Stage 1 Road Safety Audit

Proposed Re-development and Enhancement of Public Realm Market Square,
Letterkenny

Client:	Donegal County Council
Document No:	220316-ORS-XX-XX-RP-TR-7d-001
Date:	18/05/2022

Problem No.01: Footpath Widths & Gradients

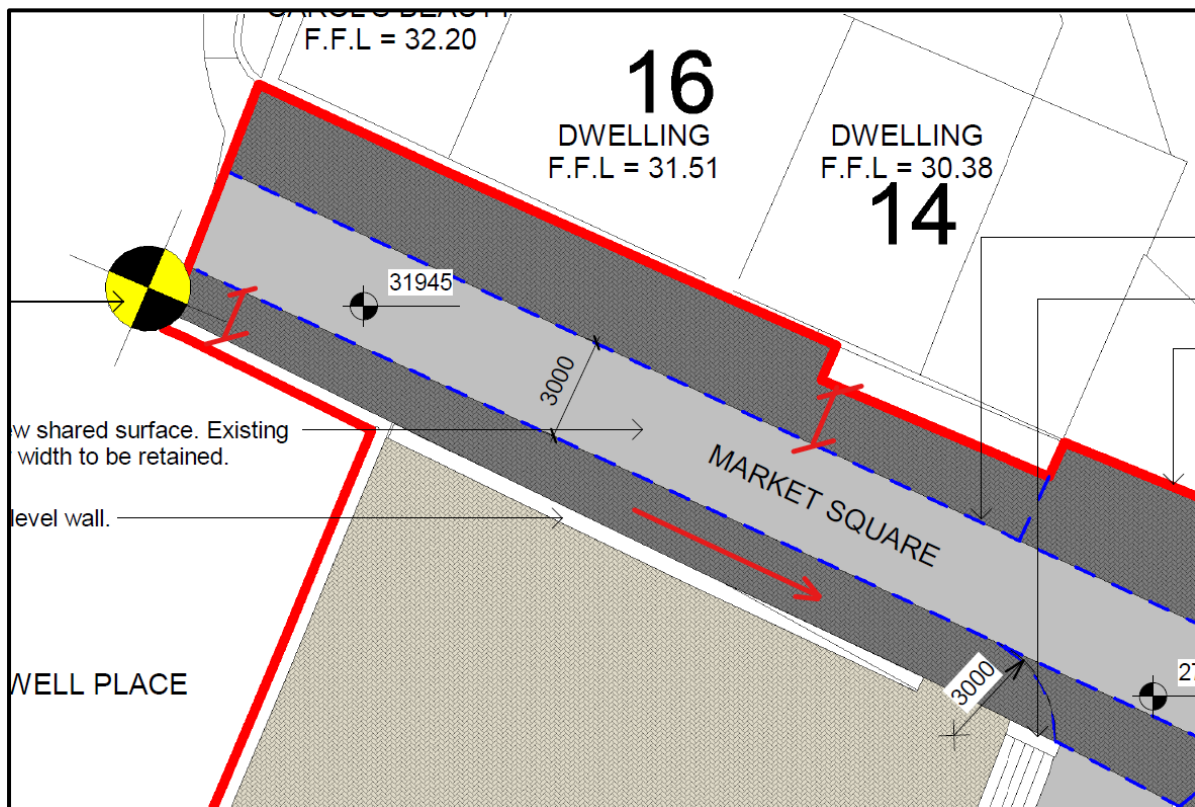
Location: Market Square Road

The audit team note that there is a lack of information for the proposed footpaths including widths and gradients. The audit team are concerned that the footpaths narrow down to inappropriate widths and include steep gradients at various locations throughout the scheme which creates an increased risk of potential conflicts both for footpath users and vehicles. Disabled road users may veer into the road at narrow sections and steep gradients which may result in wheelchair users for example losing control resulting in injury.

The design team should ensure that appropriate footpath and roads widths are provided for throughout the scheme and steep gradients be reduced within acceptable guidelines with intermittent level sections in accordance with DMURS guidelines and national Disabled Authority guidelines.

Problem Reference in Safety Audit Report	To Be Completed by the Designer			To Be Completed Audit Team Leader
	Problem Accepted (Yes/No)	Recommendation Accepted (Yes/No)	Alternative Option (Describe) (Only complete if recommendation not accepted)	Alternative Option Accepted by Auditors (Yes/No)
P1	No	No	<p>The Designer has considered Problem No. 1 and the associated recommendation to ensure that appropriate footpath and road widths are provided for and steep gradients reduced within acceptable guidelines with intermittent level sections.</p> <p>In response, the Designer clarifies that proposed footpath and road widths are either equal to or greater than existing as a result of the removal of on-street car parking that currently represents an obstruction thus providing appropriate capacity for both footpath users and vehicles that will have the effect of reducing the risk of potential conflicts. In addition, the pedestrian environment will be further enhanced as a result of additional design interventions, included ramps and boundary treatment to create a transition zone from the existing deficient environment on Castle Street to the Shared Space at Market Square. Please refer to the attached Proposed Site Layout Plan and cover letter for further detail.</p> <p>As a result, the Designer confirms that appropriate footpath and road widths are provided for throughout the scheme and that steep gradients are reduced in so far as practical within the naturally occurring topography of the site and that the scheme provides intermittent level sections in accordance with DMURS.</p>	YES

Problem No.02: Pedestrian Disabled Access

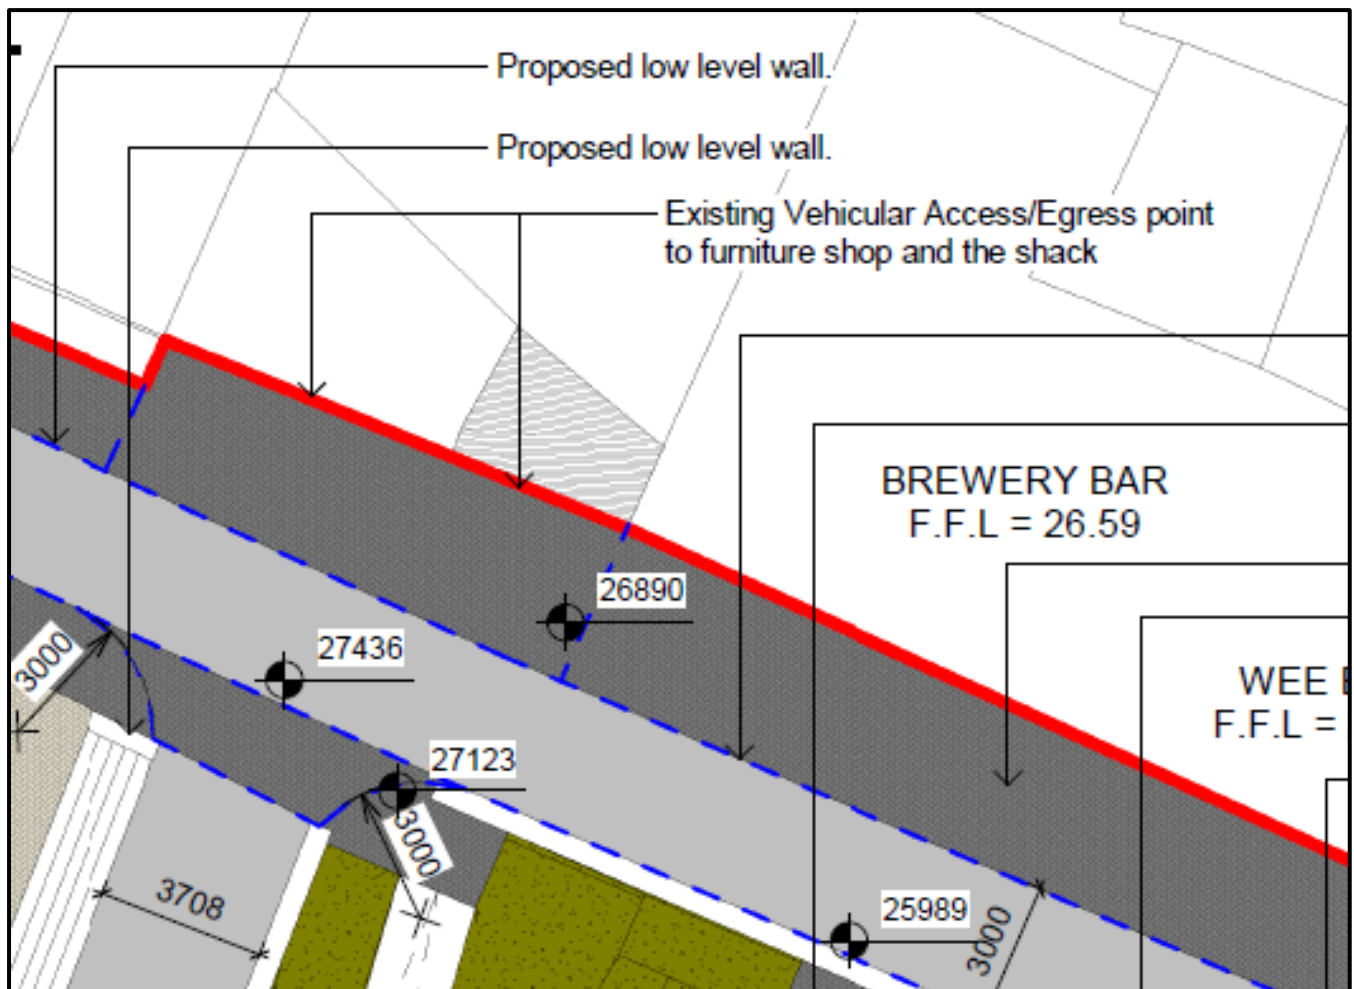
Location: Vehicle Access /Egress point

The audit team note that paving differentiation is not specified throughout the scheme and at existing vehicle access/egress points to differentiate clearly between pedestrian and vehicle surfaces. Shared surfaces can cause problems for disabled users with cognitive difficulties who may find the environment difficult to interpret and the absence of conventional kerbing poses problems for blind or partially sighted people to find their way around. The omission may result in vulnerable road users travelling in the roadway putting them at risk of conflict with vehicles.

The design team should ensure that shared surfaces and roadways are clearly distinguishable throughout the scheme. The design team should also ensure that details and locations of 'drop kerbs' and tactile paving is provided throughout the scheme at proposed crossing points

P2	Yes	Yes		
P3	Yes	Yes		
P4	Yes	Yes		
P5	Yes	Yes		
P6	Yes	Yes		
P7	Yes	Yes		
P8	Yes	Yes		
P9	Yes	Yes		
P10	Yes	Yes		
P11	Yes	Yes

Problem No. 03: Signage & Road Markings

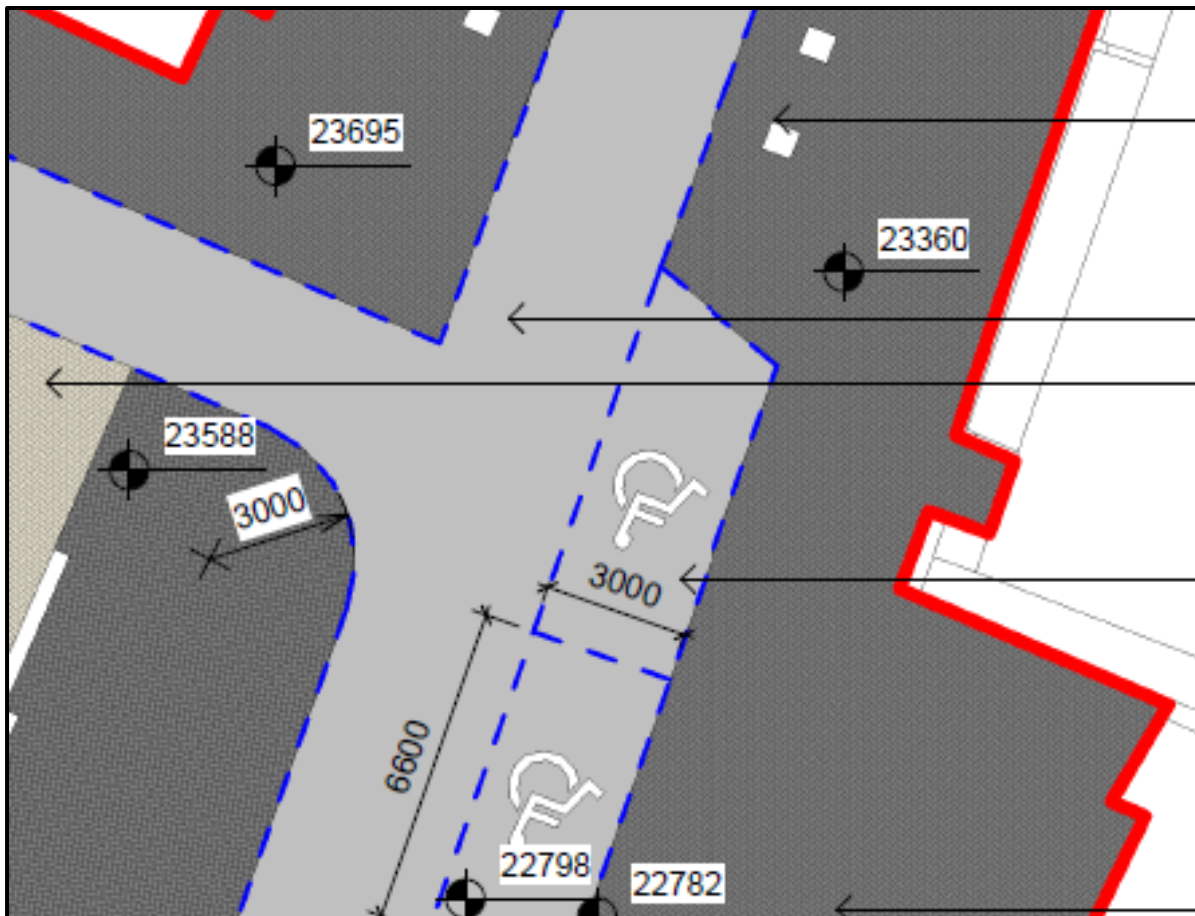
Location: Site entrance and internal roads

The audit team note that there is a lack of signage and markings for the site access junction and internal roadways on the drawings provided. Signage and markings aid in informing road users of the direction of travel and presence of vulnerable road users and ramps. Inadequate signage and road markings may lead road users not being alerted to the shared space which may result in vehicle-vehicle or vehicle-cycle conflicts causing injury.

The design team should include signage and marking on the shared roadways in line with the applicable Traffic Signs Manual.

Problem No.04: Speed Control Measures

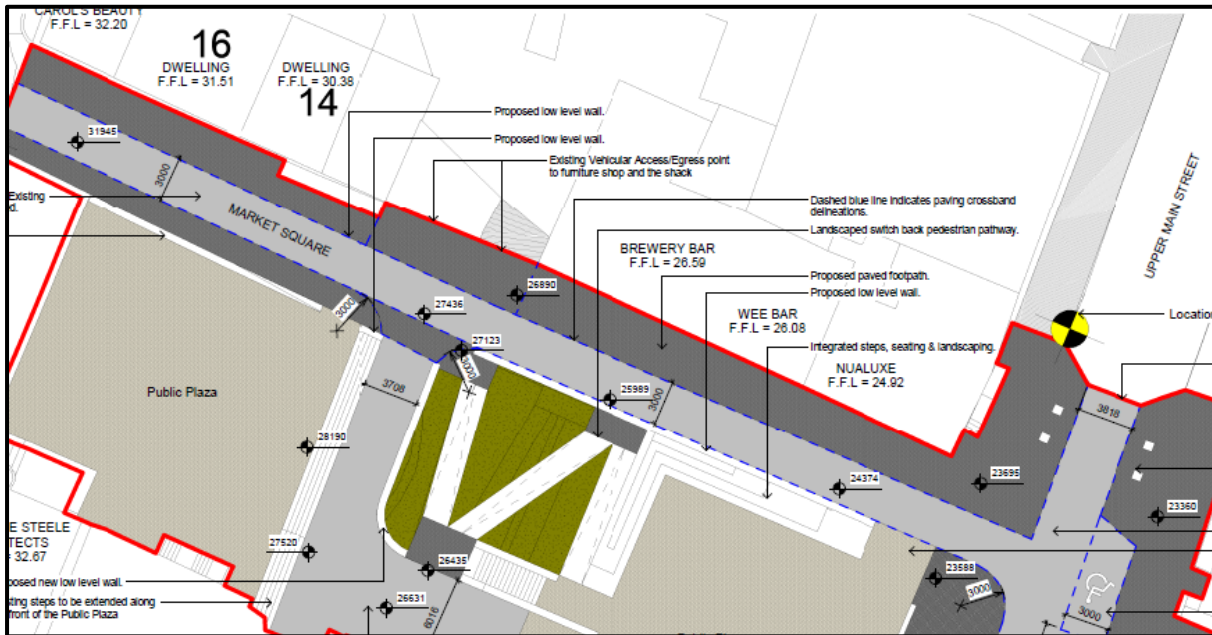
Location: Market Square Street

The audit team note from the drawings provided that there are limited speed control measures proposed within the site. The audit team are concerned that the long sections of straight road with steep downhill gradient could result in higher speeds which could put vulnerable users within the shared surface at risk.

The design team should ensure that appropriate speed control measures are incorporated within the schemes to reduce vehicular speeds.

Problem No. 05: Pedestrian Vehicle Separation

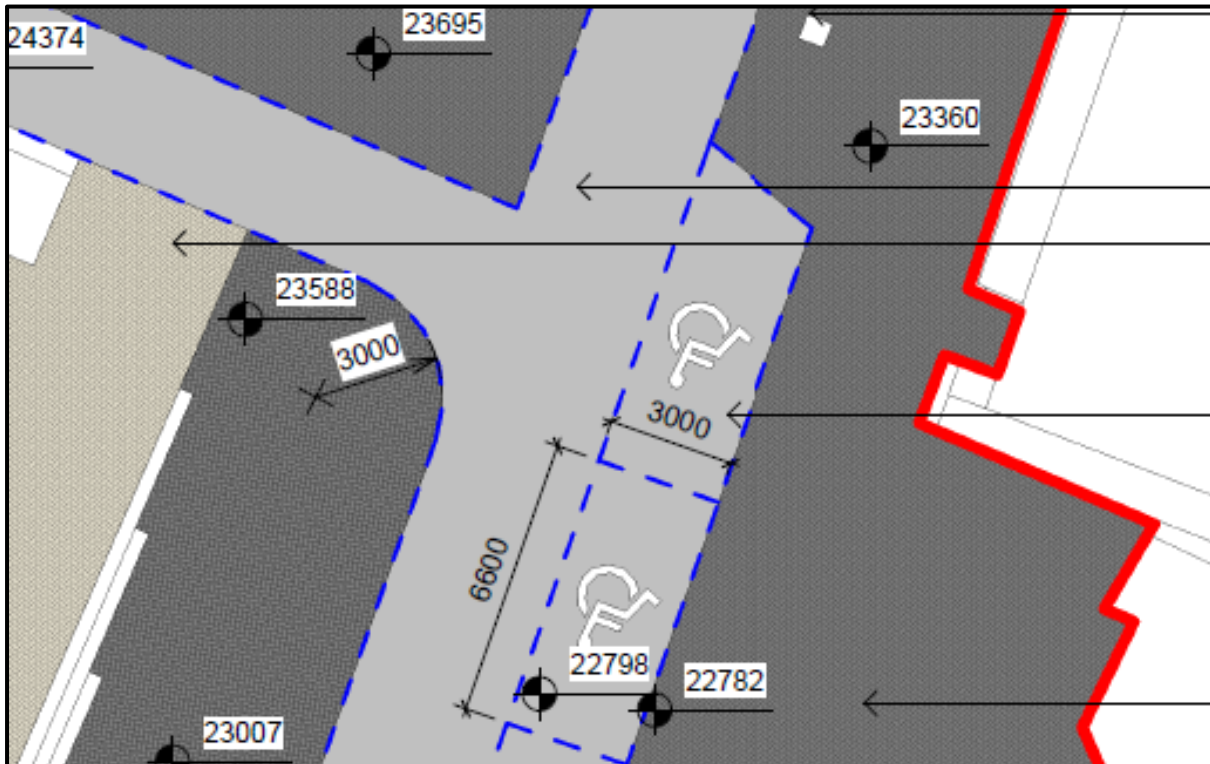
Location: Market Square / Lower Main Street Junction

The audit team note from the drawings provided that the proposed shared space does not include protection for pedestrians at locations where vehicles conduct turning movements which may result in pedestrian vehicle conflicts and injury.

The design team should consider measures for physical separation at locations where vehicles may enter pedestrian zones including junctions and parking bays.

Problem No. 06: Connections to Existing Infrastructure

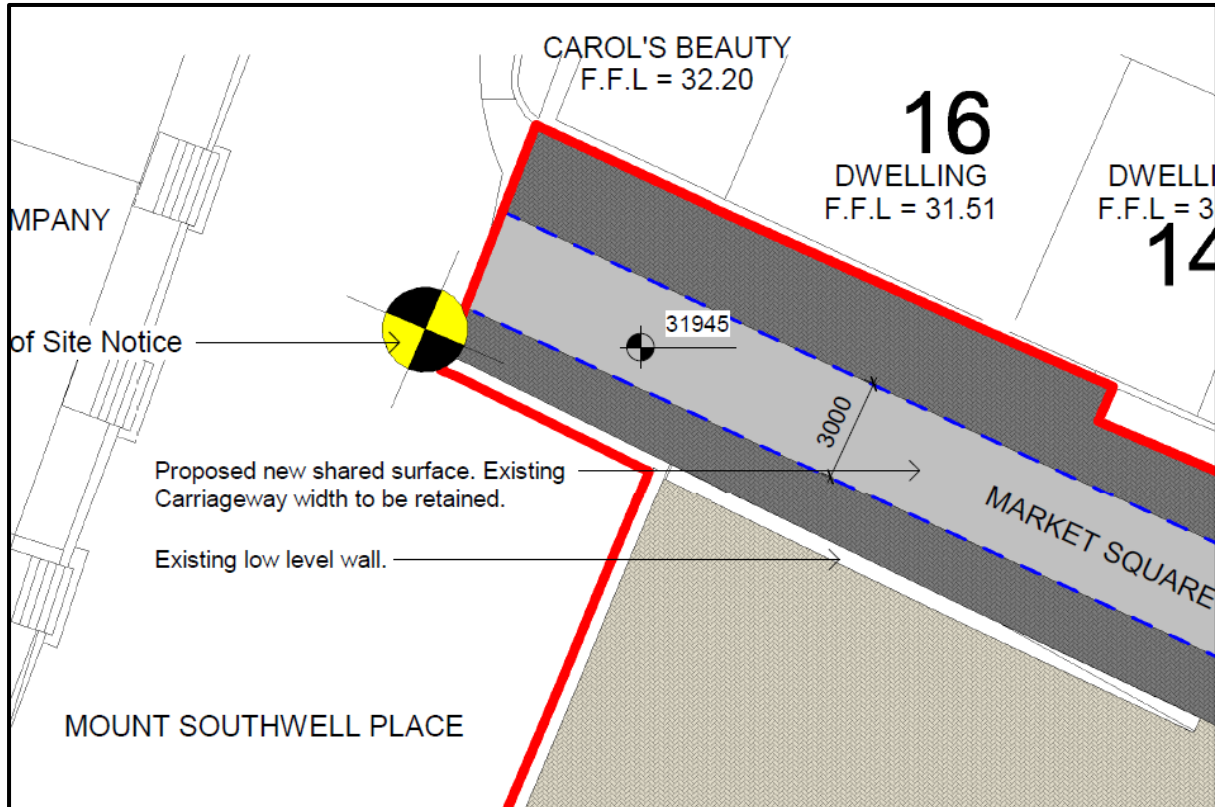
Location: North-West Tie-In Point

The audit team note from the drawings provided and site visit that the proposed new footpath to the north-west does not tie into existing footpath infrastructure. It appears the footpath terminates abruptly and leads pedestrians into the roadway in this area on both sides of the road. This could put users at serious risk of conflict with vehicles which could result in injury.

The design team should ensure that appropriate infrastructure is proposed at this location to ensure that appropriate footpath provisions are provided for to mitigate the risk of conflict with vehicles.
